**Our Case Number:** ABP-313828-22

**Re:** Demolition of existing building and construction of 5 storey over partial basement mixed use development comprising gastro pub/restaurant with off-licence, 2 retail units, 50 apartments, parking and associated site development works.  
Lands at the Silver Granite pub, Palmerstown, Dublin 20

**Third Party planning appeal vs. the decision of South Dublin County Council made under planning application, reg. ref. SD21A/0271, to issue Notification of Intention to Grant Planning Permission for proposed development comprising of "Demolition of the existing building on site and the construction of a 5-storey over partial basement, mixed-use development comprising a gastro pub/restaurant with off-licence, 2 retail units, associated bin stores, bike stores, 1 ESB sub-station, all at ground floor level; a small plant room at basement level; a total of 50 apartments (25 one beds and 25 two beds) on the upper floors, all provided with private balconies/terraces; communal roof gardens; car parking; motorcycle parking; bicycle parking; landscaping and upgrades to public realm including upgrades to existing pedestrian crossing on Kennelsfort Road Upper;

**Fig. 37: Applicant scheme includes 11 no. primarily north facing apartments = overdevelopment (1)**

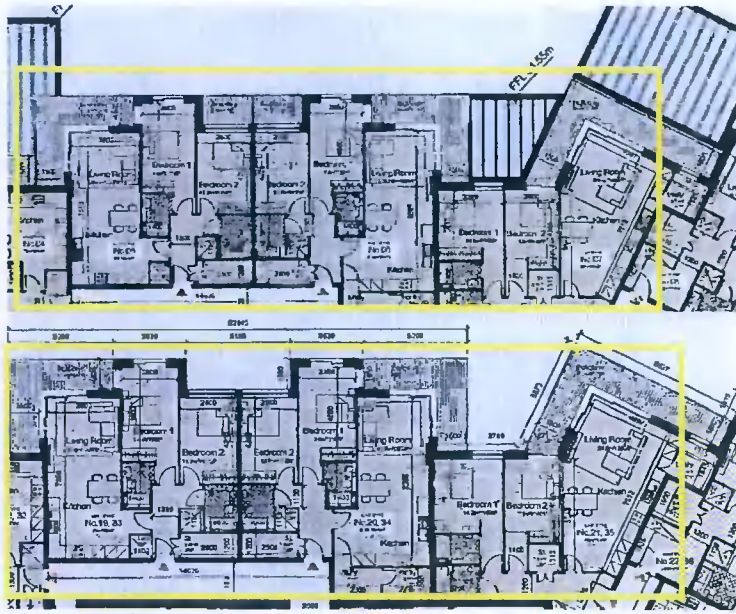
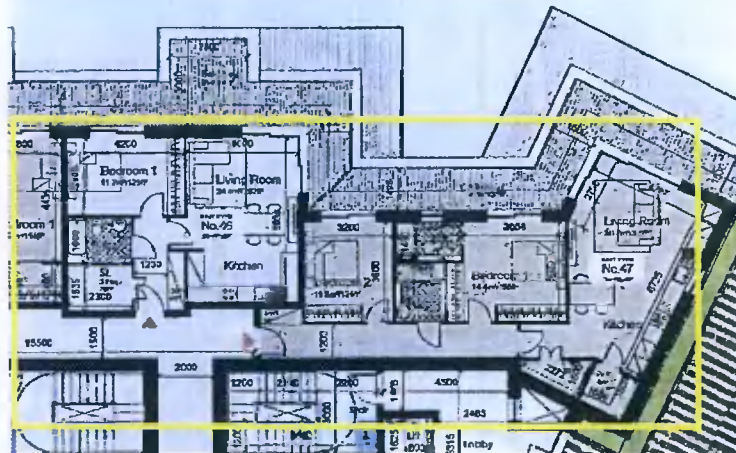
We note that Apartment No. 46 is technically dual aspect as it has one east facing window. This east facing window opens onto the roof terrace and, as such, would need to be obscure glazed and/or removed. The window would offer poor amenity.

**Fig. 39: Applicant scheme's social housing units are single aspect**

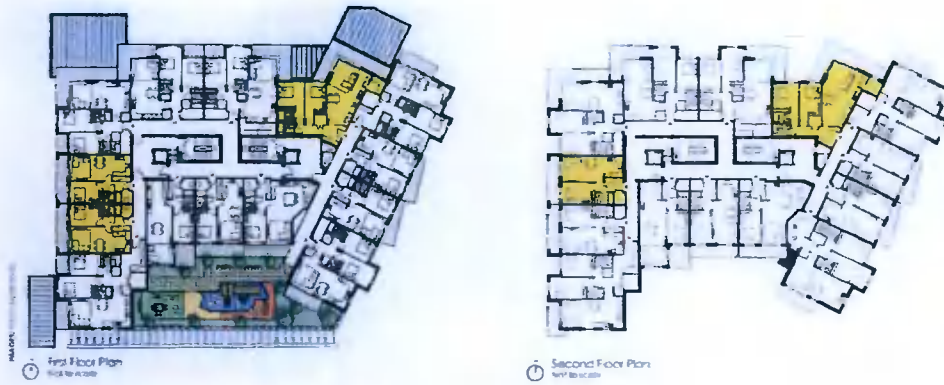
4. BPS has reviewed the Applicant's proposed social housing units (see Fig. 39), and these are primarily single aspect units. The Applicant can argue that the units offered toward the east end of the north elevation is dual aspect, but it is not really – it just has angled north facing windows. The provision of only single aspect windows when the scheme could be designed to provide all dual aspect units for social housing tenants is a sign of overdevelopment of this site.

**Fig. 40: Scheme's south elevation impacts negatively on properties to the east and southeast**

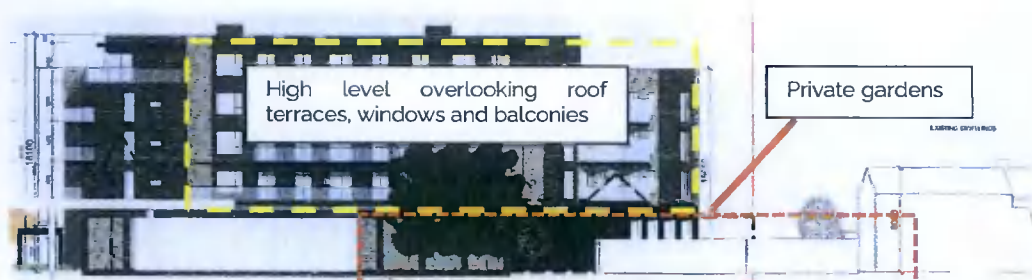
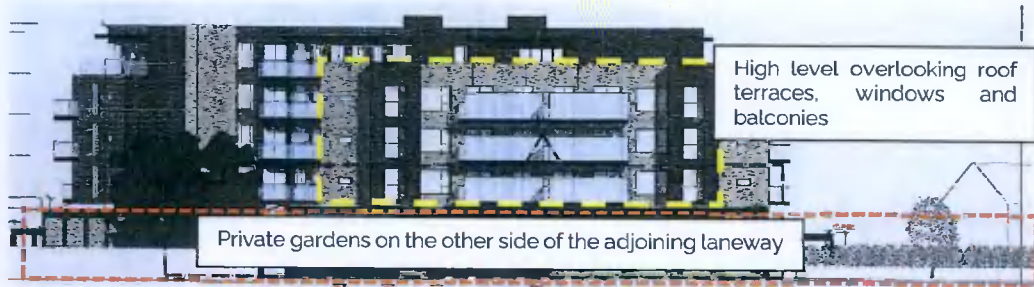
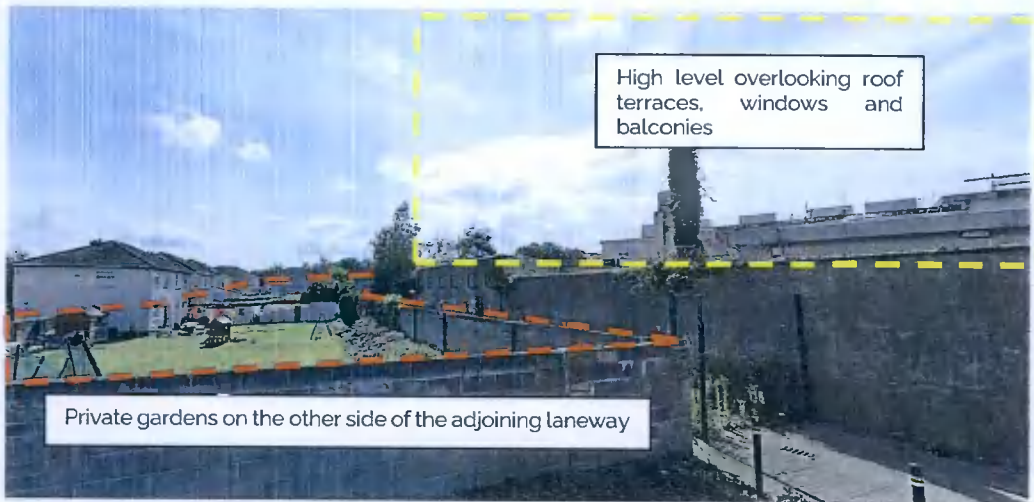
2. The scheme appears out of context and excessive in scale relative to nearby properties. See also our client's attached original Planning Objection Report submitted to SDCC.

**Fig. 43: Proposed bin lorry access and turning area immediately adjoining private rear gardens**

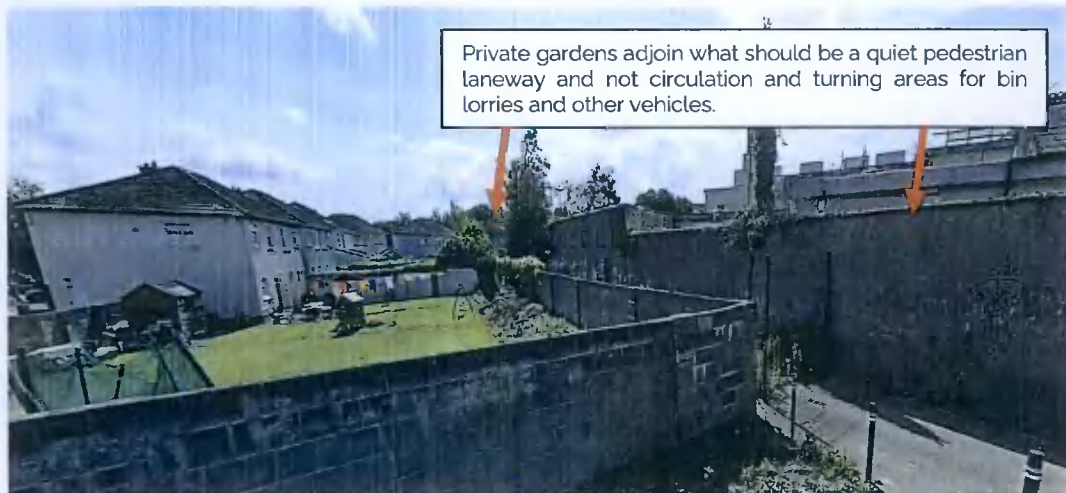
Our client notes the reference to the "access road to the east". In fact, this is a quiet laneway which currently receives no traffic. The Applicant proposals would serve to de facto privatise the lane. The SDCC Planner's Report does not address this as an amenity issue, etc. despite the adjoining laneways being sited alongside rear gardens.

**Fig. 10: The siting of the red line boundary is not the ownership boundary & is misleading**

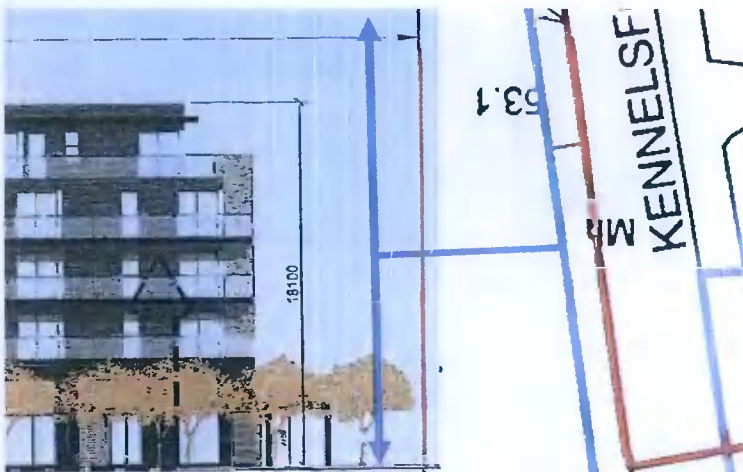
Repeatedly through this planning application's elevation drawings, the Applicant shows the red line site boundary. This includes instances such as at the east and west sides of the proposed building where distances to the red line boundaries are shown. In these instances, the drawings are misleading as they show areas outside of the Applicant's control such as the public footpath to the west and the laneways to the east (see Fig. 10).

**Fig. 12: Haphazard proposal over 2 sites & subdivision of the existing shopping centre car park**

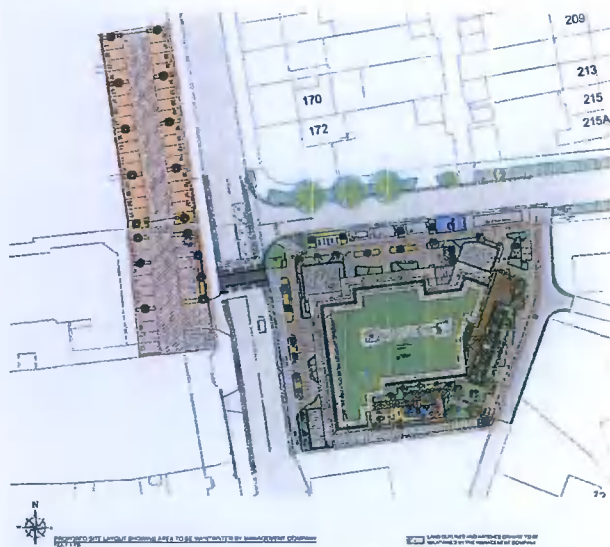
It is clear the Applicant has sought throughout this planning application's planning, design, and transport reports to avoid discussion of on what basis it is proposed to effectively subdivide an existing shared surface car park serving Palmerstown Shopping Centre and to allocate these parking spaces only to this new scheme.

**Fig. 14: Applicant proposals for a new vehicular access/service route are outside the blue line boundary**

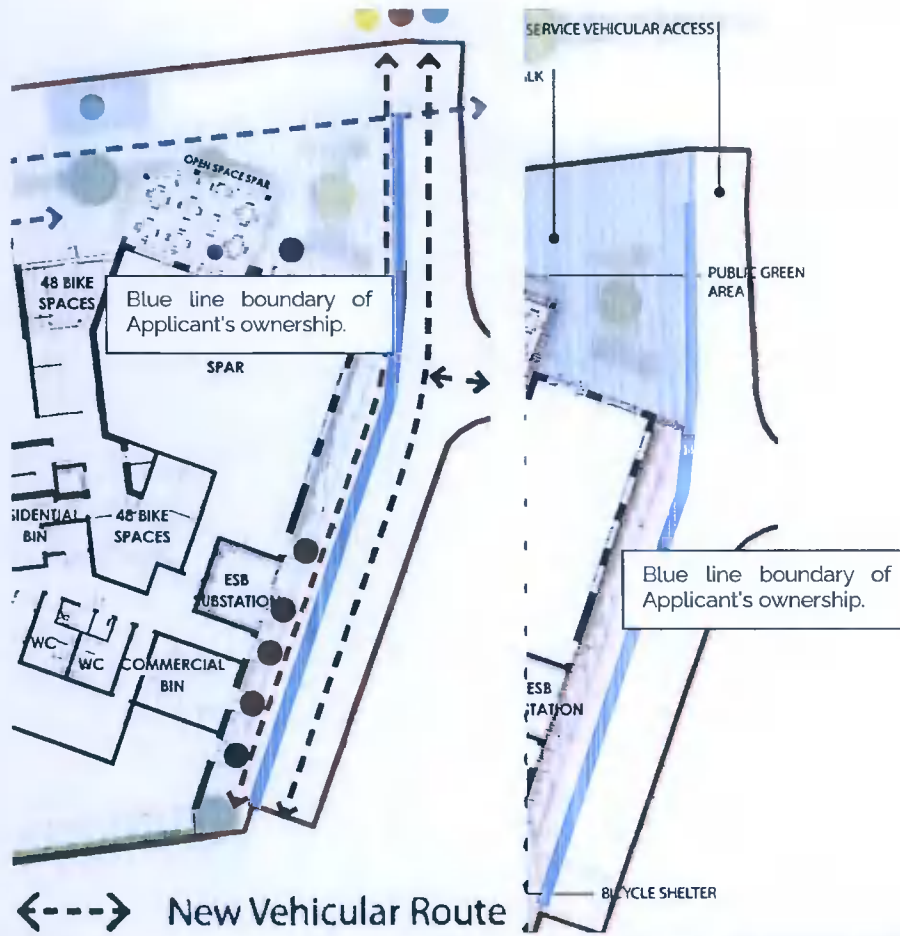
Our client notes the Applicant's intention to remove the existing eastern boundary wall serving their site and to effectively address and make use of the existing laneways to the east of the site. The proposal amounts to the incorporation of the adjoining lane areas into the Applicant's site boundary despite their not owning them. The actual blue line boundary of the Applicant site is shown in Fig. 14.

Our client supports the residents of Oakcourt Grove and Wheatfield Road in opposing the inclusion of these laneways into the scheme for, inter alia, vehicular traffic. This proposal should not be accepted in principle and the Silver Granite Pub should continue to maintain a boundary wall to the lanes and should not be allowed to try to effectively incorporate these lanes into their scheme.

Fig. 21: Applicant scheme drawings are misleading as to the site's actual blue line boundary

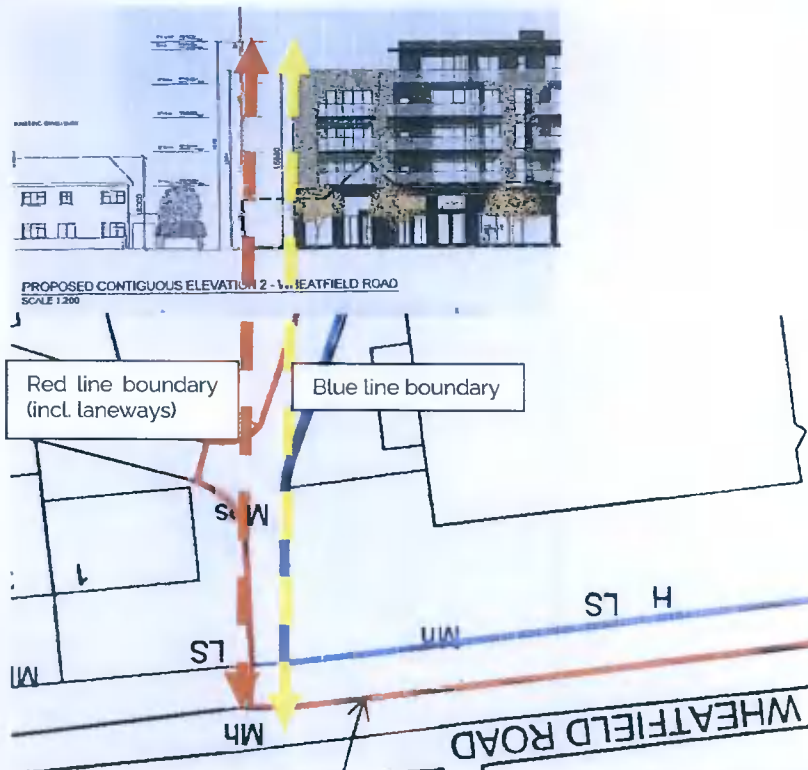
The Applicant has chosen to include the lanes to the east of the site within the red line boundary though they do not own these. They then provide drawings, such as the contiguous elevation shown in Fig. 21, which show the scale of the proposed development relative to the red line boundary. This has the effect of making the eastern boundary of the Applicant's property seem setback further than it is. The lanes to the east actually appear to be the setback provided by the Applicant when they are not.

The result of the laneways being incorporated into the Applicant site is that the proposed building has been sited too close to the residential properties located to the east. The proposed building needs to be setback from the laneways thereby increasing the setback to these properties.

**Fig. 22A: Applicant scheme includes 11 no. primarily north facing apartments = overdevelopment (1)**

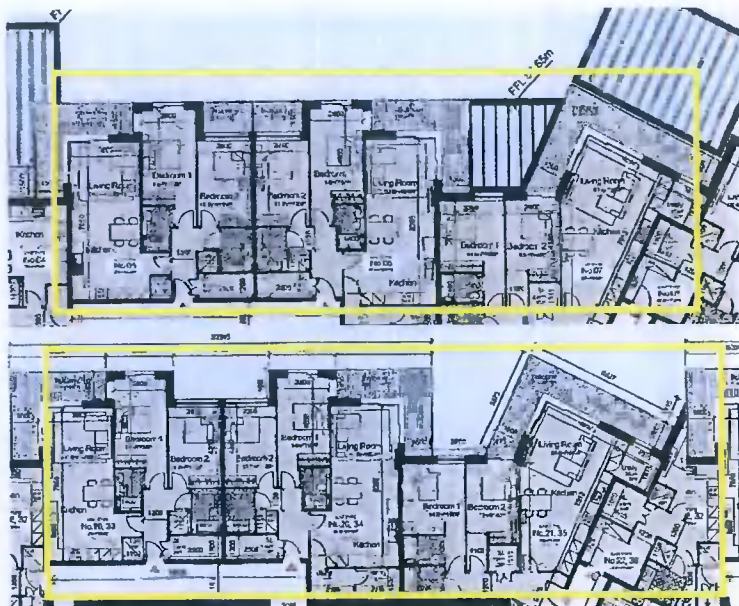
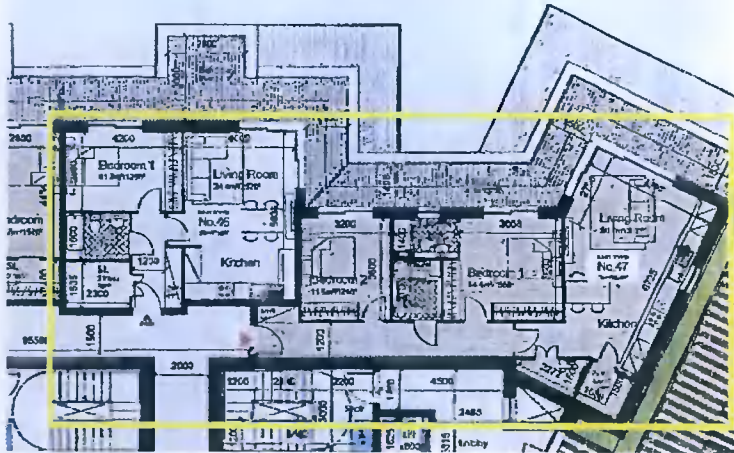
We note that Apartment No. 46 is technically dual aspect as it has one east facing window. This east facing window opens onto the roof terrace and, as such, would need to be obscure glazed and/or removed. The window would offer poor amenity.

**Fig. 23: Applicant scheme’s social housing units are single aspect**

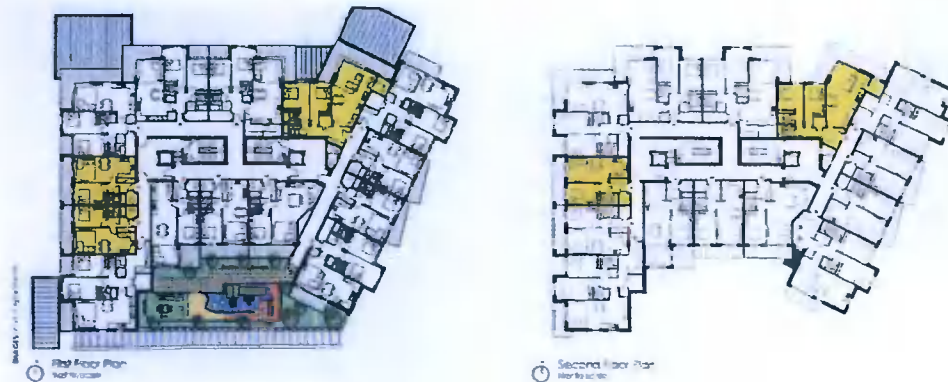
The provision of only single aspect windows when the scheme could be designed to provide all dual aspect units for social housing tenants is a sign of overdevelopment of this site.

**Fig. 28: Scheme's areas communal open space proposed impact negatively on surrounding amenities**

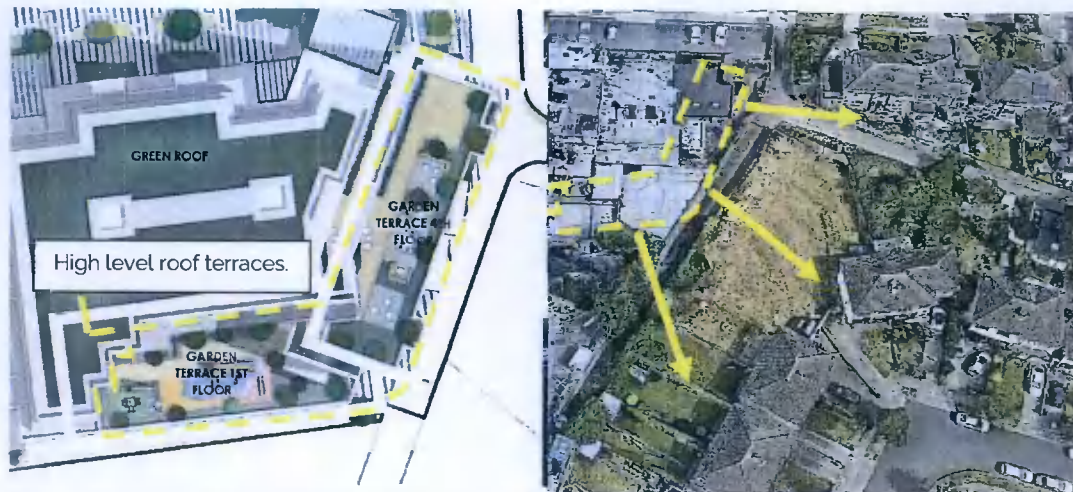
The Applicant has based their communal open strategy on hope that SDCC will disregard these concerns in favour of this scheme. Our client submits that this is not acceptable. The proposed terraces would place the needs of the scheme developers above the right of residential property owners in the vicinity to be protected from overlooking, etc.
